MEMORANDUM

UTAH DEPARTMENT OF TRANSPORTATION

SUBJECT: Standards Committee Meeting Minutes and Next Meeting

Specification/Drawing/Item Title: EN Standard Drawings, Temporary Environmental Controls, Environmental Control Supervisor

TEMPORARY
EROSION CONTROL
(CHECK DAMS)

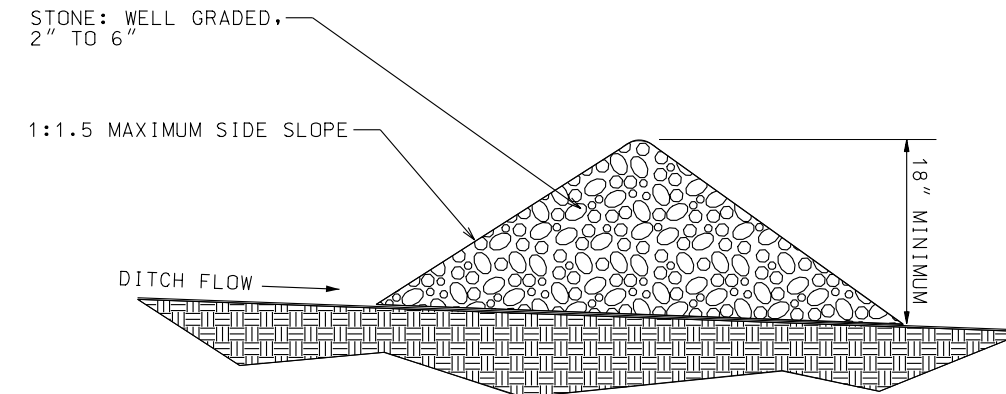
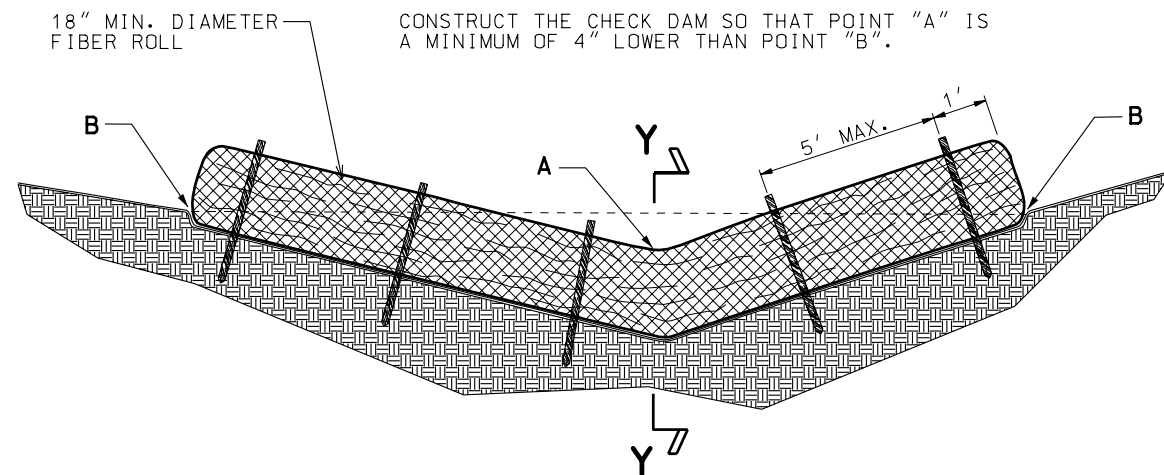
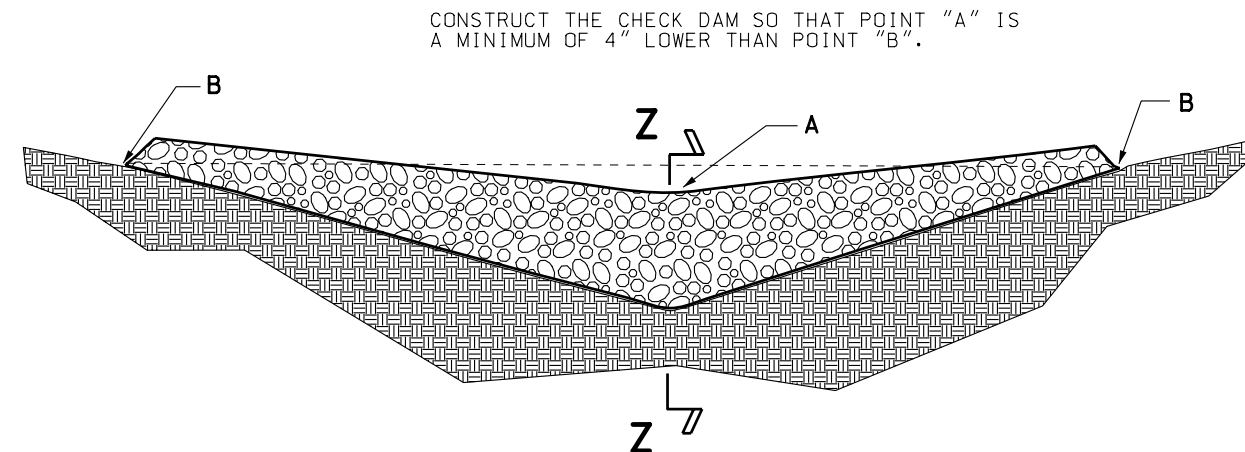
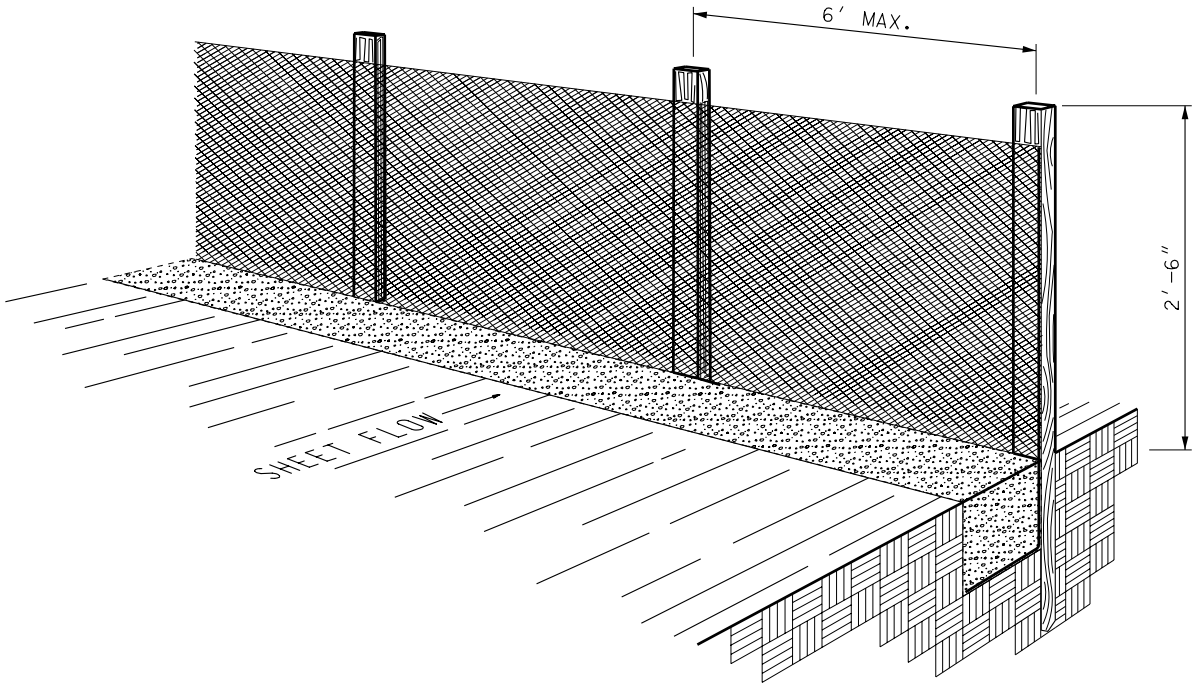
- A. Why? Detail the reason for changing the Standard (Specification or Drawing), what has initiated a new Standard, or what has caused a new or changed item of interest.
 1. We have received comments on the current standards from Construction and Maintenance requesting changes.
 2. Some of the Best Management Practices (BMP) are out-dated and need to be eliminated and replaced with more state-of-the-art practices.
- B. How is Measurement and Payment handled? Existing (from the measurement and payment document), modified, or new measurement and payment to be included with all Standard Specifications or Supplemental Specifications.
 1. Temporary Environmental Controls Spec: Old BMP's that are no longer used will need to be eliminated from the list and new ones will need to be added to the list.
 2. ECS Spec: No changes.

TEMPORARY EROSION CONTROL (SILT FENCE)	
STANDARD DRAWING TITLE	
STD DWG	EN 2

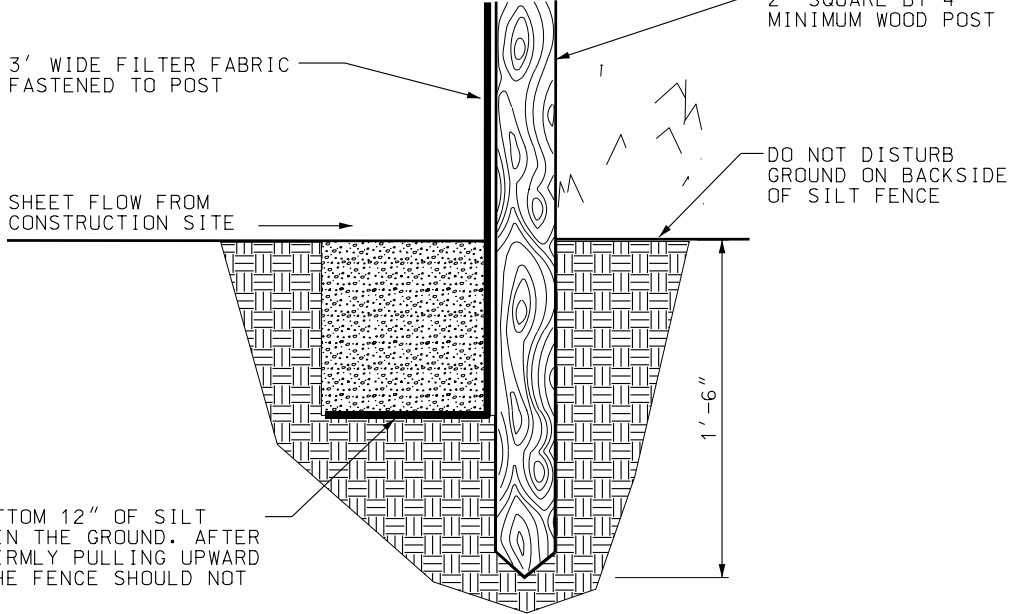
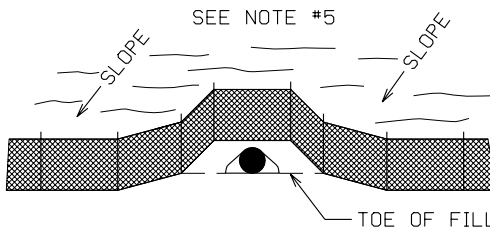
REVISIONS		REMARKS	
NO.	DATE	APPR.	REMARKS
1	06/30/05	T.J.	REVISED ENTIRE DRAWING.

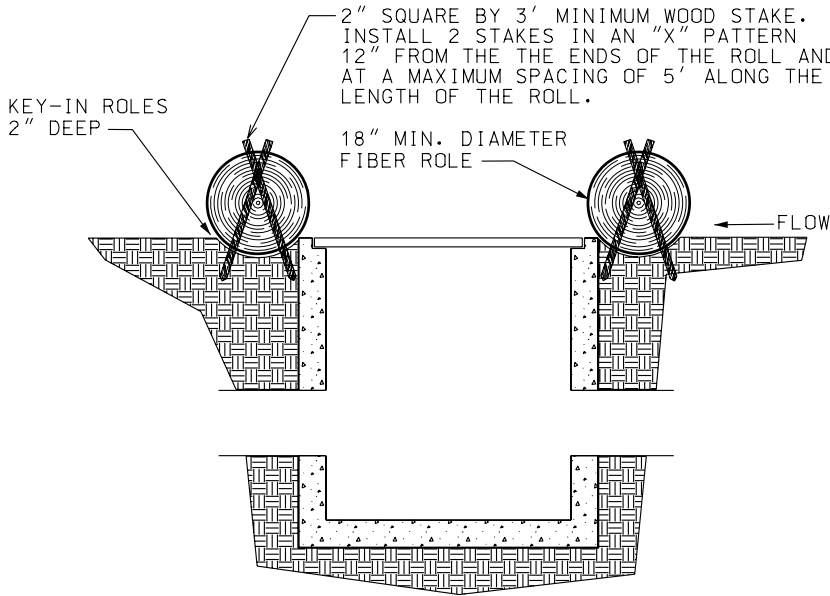
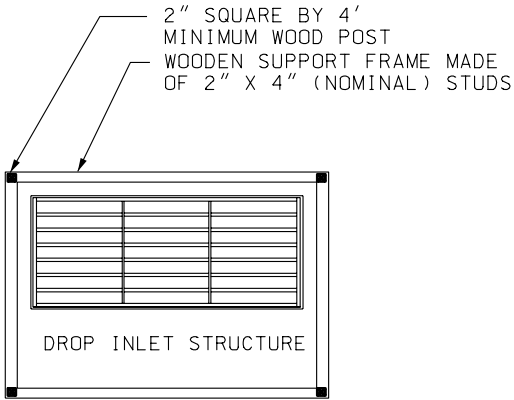
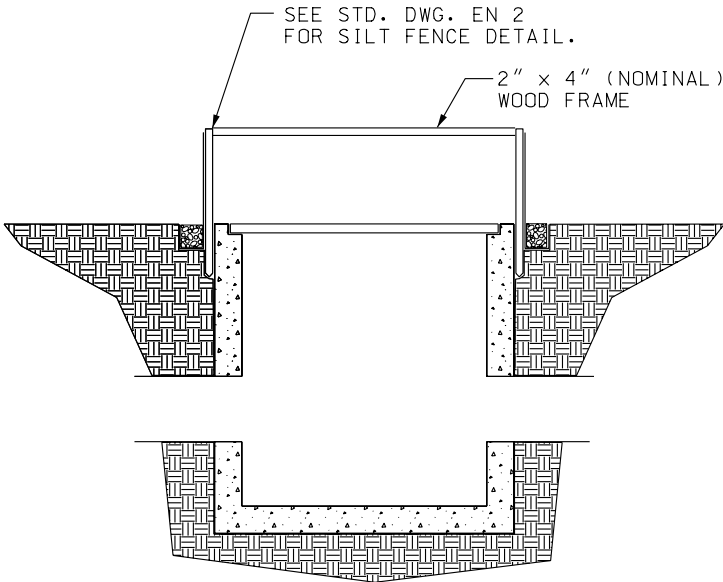
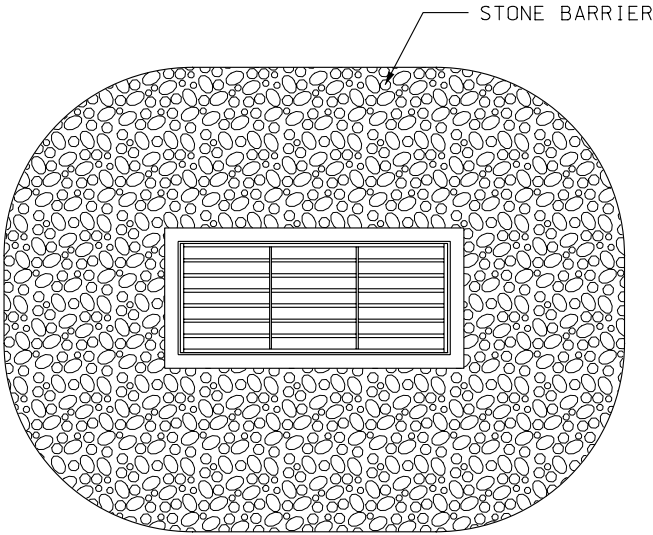
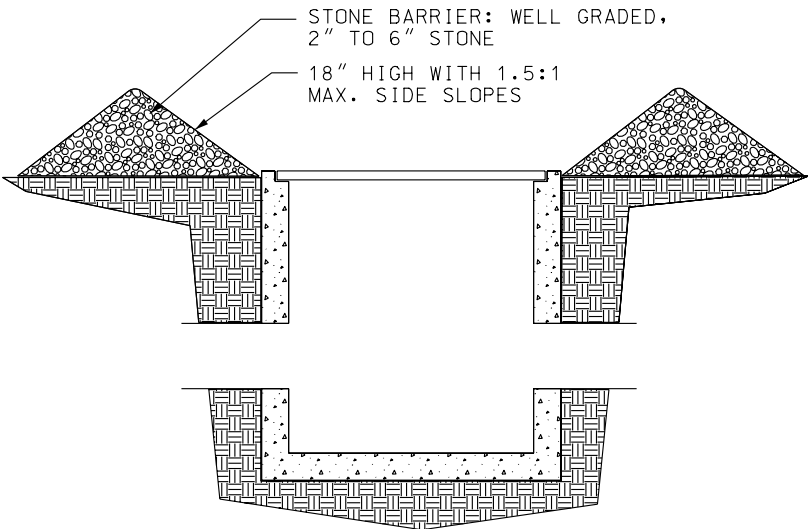
REVISIONS		1	06/30/05	T.J.	REVISED ENTIRE DRAWING.
UTAH DEPARTMENT OF TRANSPORTATION STANDARD DRAWINGS FOR ROAD AND BRIDGE CONSTRUCTION SALT LAKE CITY		RECOMMENDED FOR APPROVAL		DATE	
		CHAIRMAN STANDARD DRAWING COMMITTEE		DATE	
TEMPORARY EROSION CONTROL (DROP INLET BARRIERS)		APPROVED		DATE	
		DEPUTY DIRECTOR		DATE	
STD DWG EN 4		STANDARD DRAWING TITLE		REMARKS

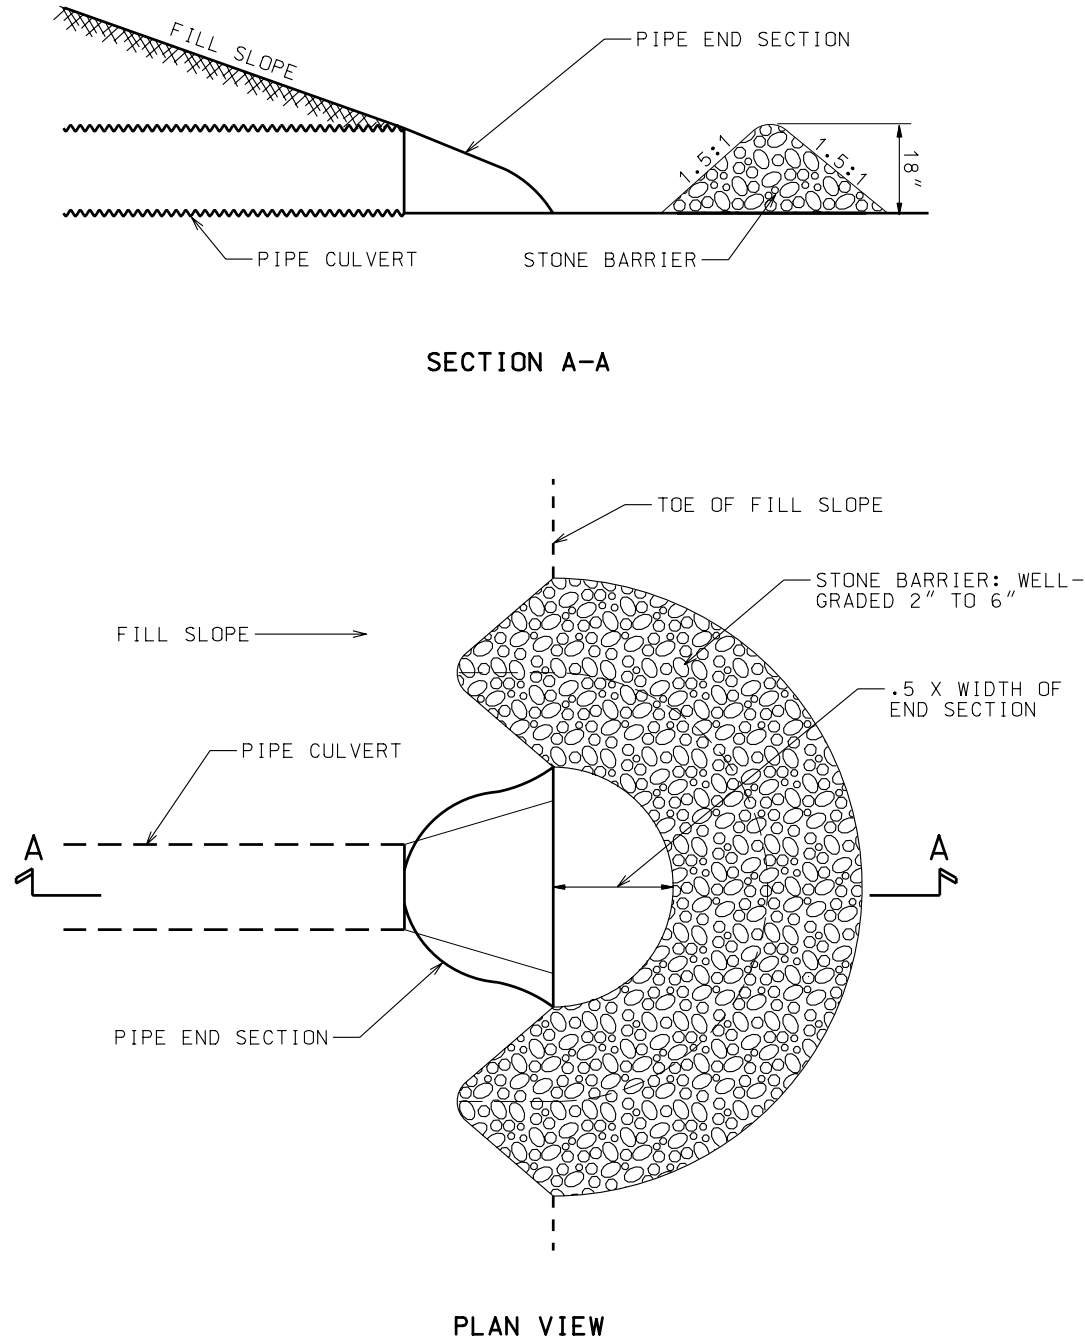
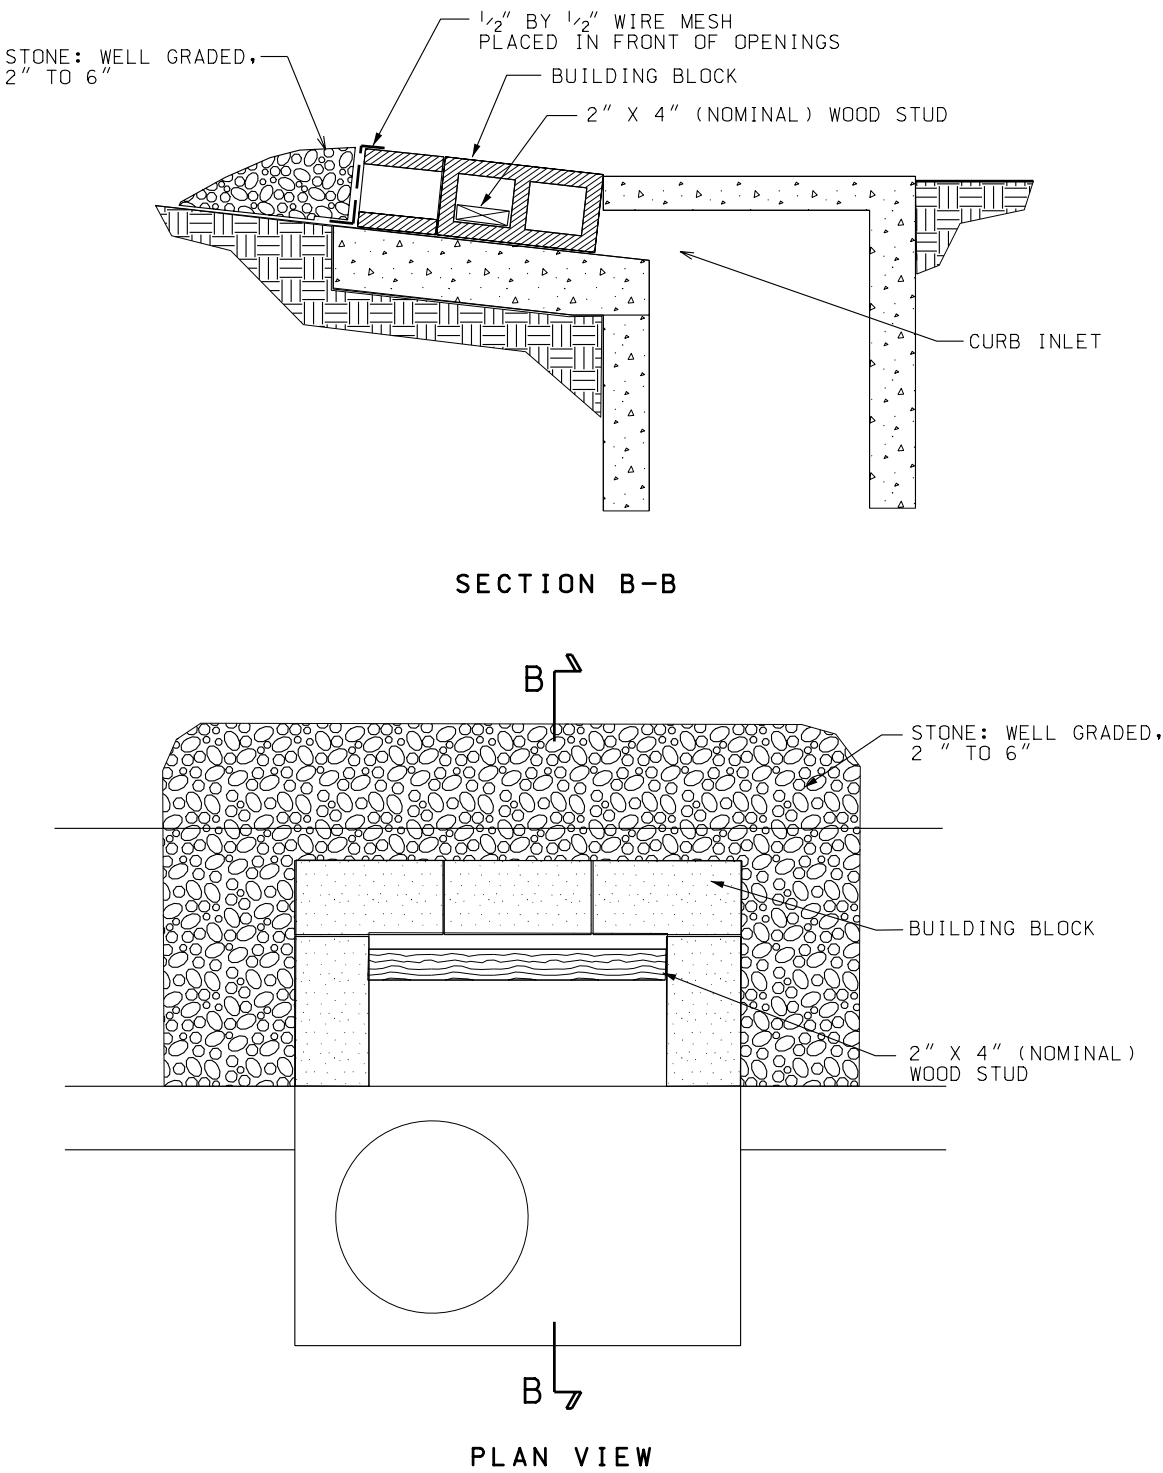
REVISIONS				REMARKS			
1	06/30/05	T.J.	REVISED ENTIRE DRAWING. TITLE CHANGED.				
UTAH DEPARTMENT OF TRANSPORTATION				STANDARD DRAWING TITLE			
STANDARD DRAWINGS FOR ROAD AND BRIDGE CONSTRUCTION				TEMPORARY EROSION CONTROL (PIPE INLET AND CURB INLET BARRIERS)			
RECOMMENDED FOR REVIEW				DATE			
CHAIRMAN STANDARD COMMITTEE				JUN.30, 2005			
APPROVED				JUN.30, 2005			
DEPUTY DIRECTOR				DATE			
				NO.			
				DATE			
				APPR.

MEDIAN BREAK
EXAMPLE

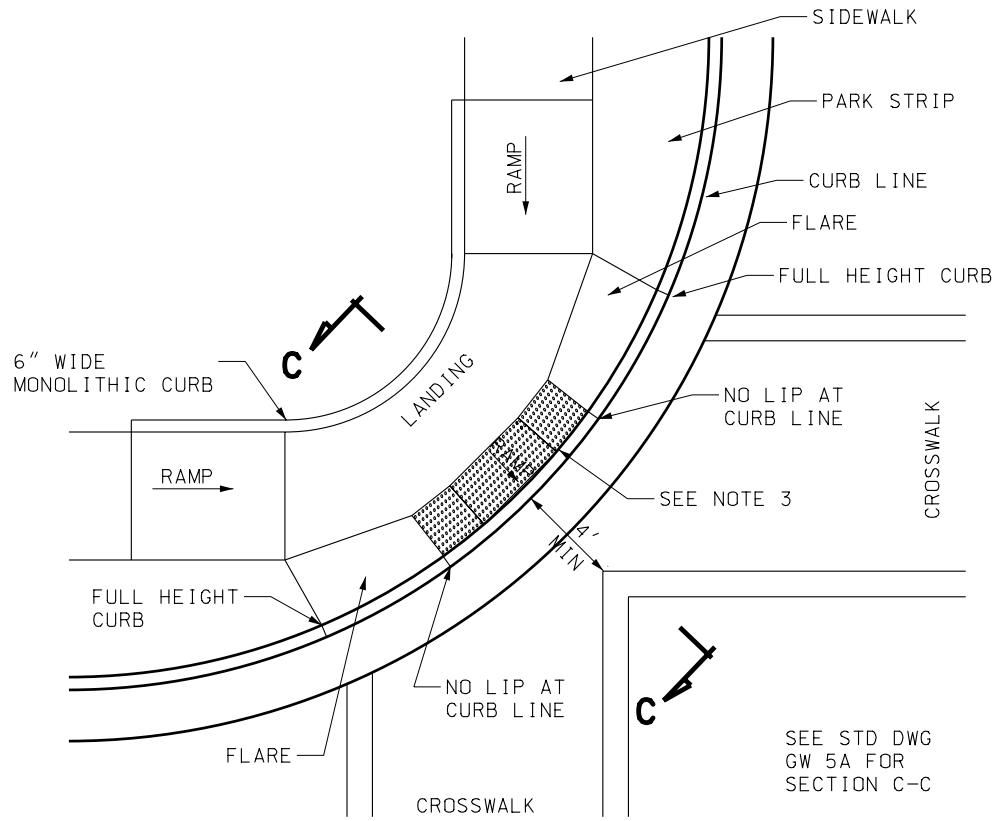
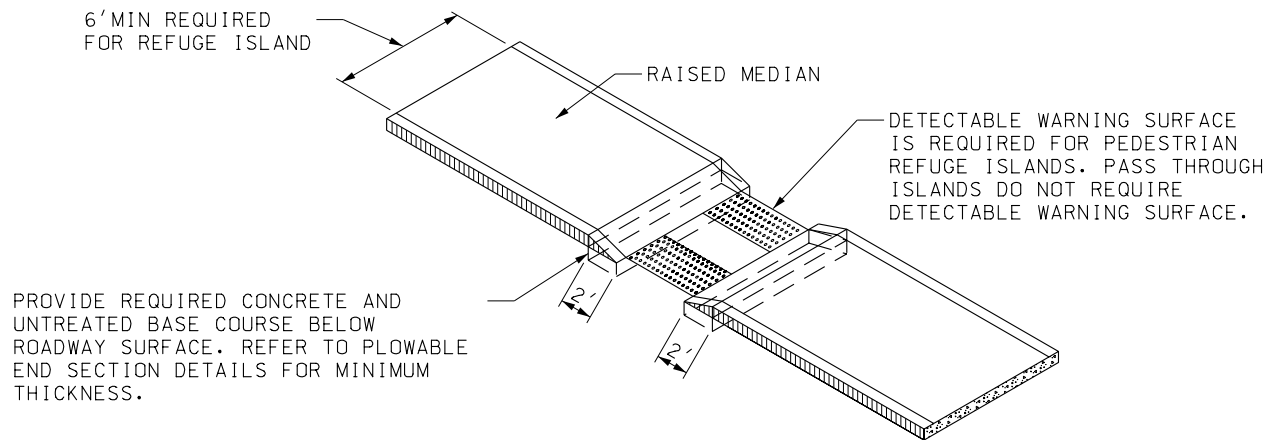
This change was requested by UDOT Maintenance Division to eliminate potential snag points for snow plows. During our Statewide Ped Ramp seminar series I didn't receive any negative comments regarding this change.

REVISIONS
1 06/30/05 L.M. MEDIAN BREAK EXAMPLE MODIFIED.

This change will eliminate potential snag points for snow plows, and poses no safety concern for pedestrians or motorists.
